ACRS MEETING MINUTES ON THE MEETING OF THE  
WESTINGHOUSE WATER REACTORS SUBCOMMITTEE  
FEBRUARY 12, 1986  
WASHINGTON, DC

SUBJECT: STAFF ACTIONS RESULTING FROM THE INVESTIGATION  
OF THE NOVEMBER 21 SAN ONOFRE NUCLEAR GENERATING  
STATION, UNIT 1 EVENT (NUREG-1190)

PACIFIC VALVE DESIGN

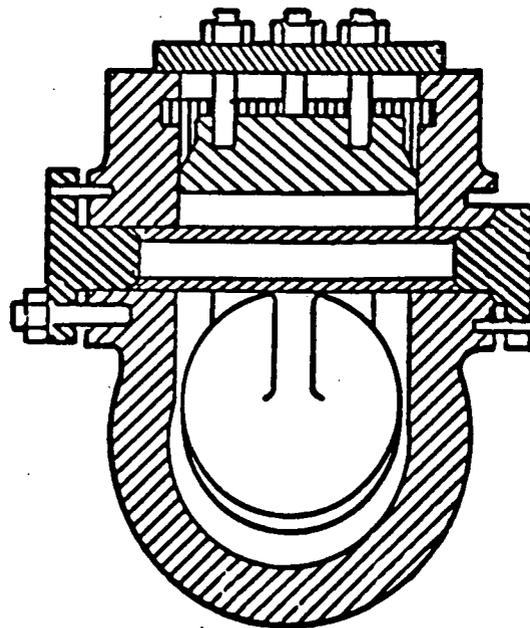
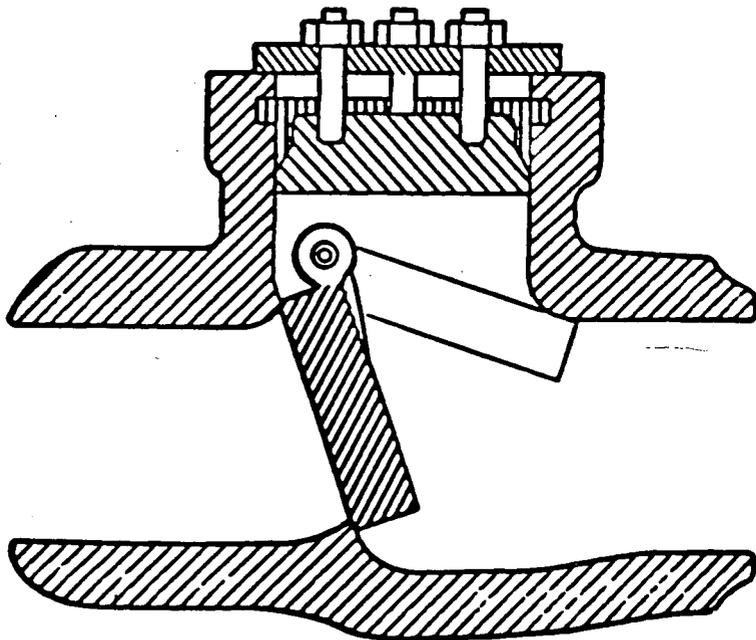
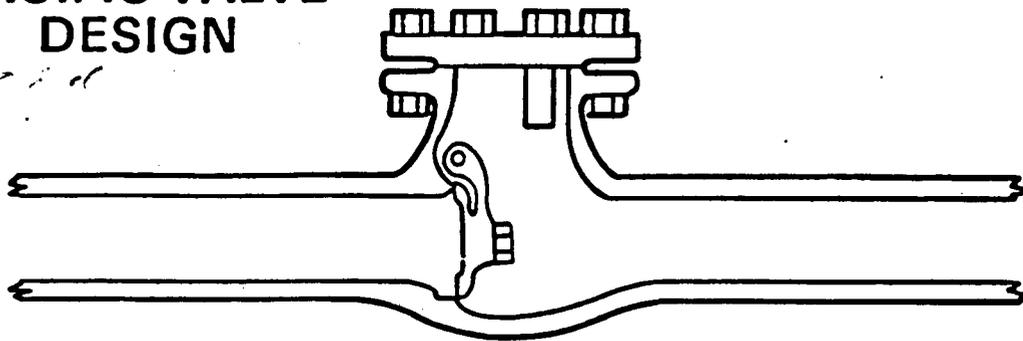
4. SCE intends to replace the check valves of the type involved in the check valve failures with a different design. The old (Pacific Valve) valve design and the replacement (Atwood-Morrill) valves are shown on Figure 1. The configuration of the feedwater lines will be modified as to reduce the potential for water hammer. A number of other modifications are being proposed by SCE. These modifications are summarized on Attachment D.

- (f) Placement of check valves downstream of flow control valves should be reviewed at SONGS-1. The flow control valves will cause downstream turbulence which could inturn cause flow-induced vibration of the check valve disks.

- o REPLACE 8 PACIFIC CHECK VALVES WITH ATWOOD-MORRILL VALVE DESIGN  
*2-12"*  
*2-10"*  
*8 1/2"*
- o PROVIDE IMPROVED IN-SERVICE TEST CAPABILITY FOR REPLACEMENT VALVES
- o SLOPE "B" FEEDWATER PIPE INSIDE CONTAINMENT (*away from SC*)
- o ADD CHECK VALVES, WITH IST PROVISIONS, IN EACH FEEDWATER LINE INSIDE CONTAINMENT
- o PROVIDE FOR AUTOMATIC CLOSURE OF MAIN FEEDWATER FCV'S FOLLOWING UNIT TRIP AND LOSS OF MFW PUMPS
- o EVALUATE ADDITION OF VOID SENSING DEVICE WITH CONTROL ROOM ALARM
